RC1

We sincerely thank the referee for taking the time to evaluate our manuscript and for providing positive and constructive feedback, which has significantly contributed to improving the quality of the paper. Our detailed responses to the comments are presented below.

Figure A1. Map of current Emission Control Areas (ECAs) (filled orange area), including The North American area, The Baltic Sea area, the Baltic Sea, The North Sea area and The Unites States Caribbean (IMO, 2021).

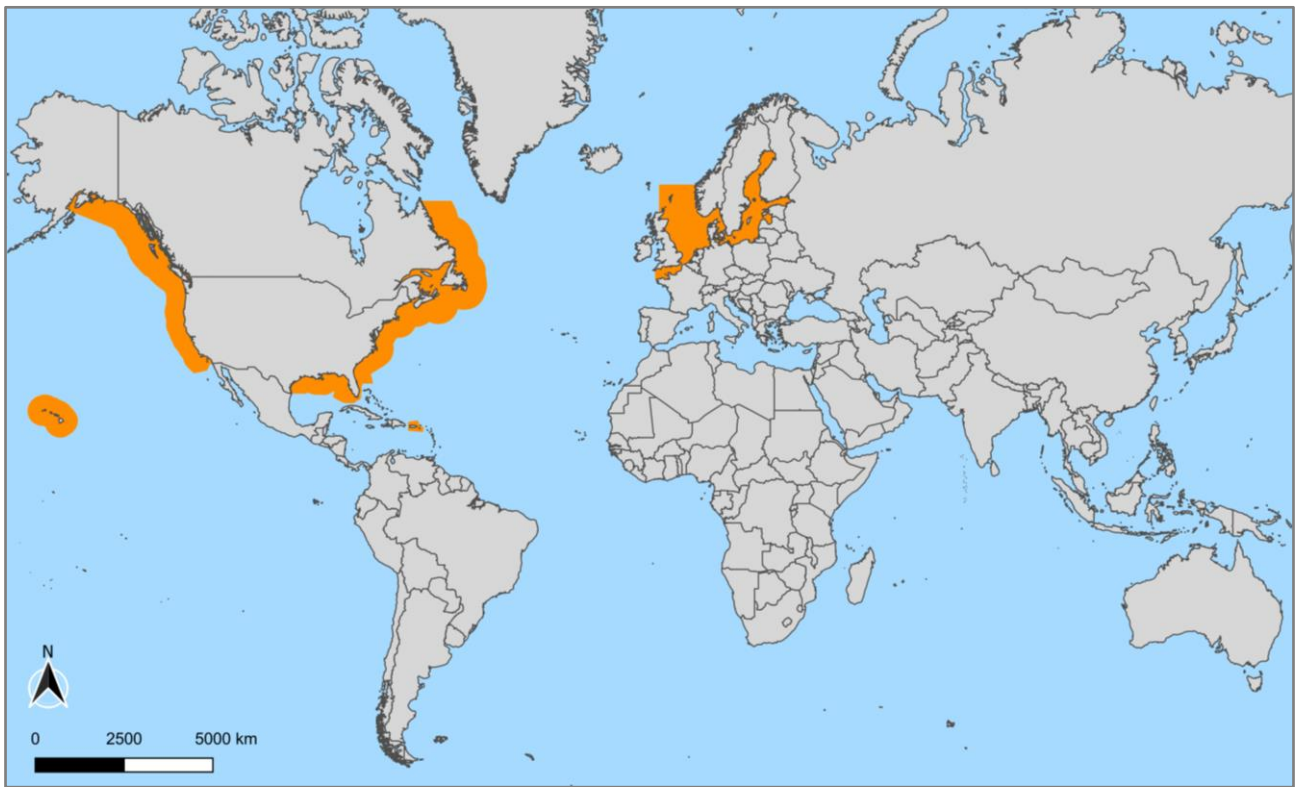
- *Line 58: Although there are some details on the MARPOL convention regulations, a few additional clarifications would be useful to expand these results to other locations. For example.*
 - *Is the port in an ECA, and how far offshore does this extend.*
 - *Please expand on the usage of SCR systems. It is discussed that these allow for higher sulphur fuels in the ECA, are these also required offshore? Is there any information on how common these systems are? It is also noted that these scrubbers are shut down in the harbor (line 445) - Does*

this increase the sulphur emissions?

- Figure A1 in the reply supplement illustrates the locations of existing ECAs in 2021 (campaign period). The Mediterranean Sea, including Marseille, will only become an Emission Control Area (ECA) for SO_x from May 2025 under MARPOL Annex VI Regulation 14. All ships operating in the Mediterranean Sea must either use fuels with a sulphur content below 0.1% or adopt emission control technologies that achieve an equivalent emissions level. However, before this date and since 2010, ships at berth or at anchor for more than two hours were subject to European regulations, that imposed the same emission limits as those in ECAs (<0.1%). At sea ships in the Mediterranean had to comply with the global IMO sulphur cap of 0.5% that has been effective since 2020. To enhance clarity and highlight the relevance of our results to both ECA zones when ships are docked and other areas during navigation, we have included the following paragraph at line 123:

“In 2021, the port of Marseille was not within an Emission Control Area (ECA) and followed the global sulphur cap of <0.5%. However, EU regulations required ships docked for less than two hours to limit sulphur emissions to <0.1%, as in ECAs. From May 2025, the Mediterranean, including Marseille, will become an ECA (ECAMED), enforcing a <0.1% sulphur limit for all vessels operating within it.”
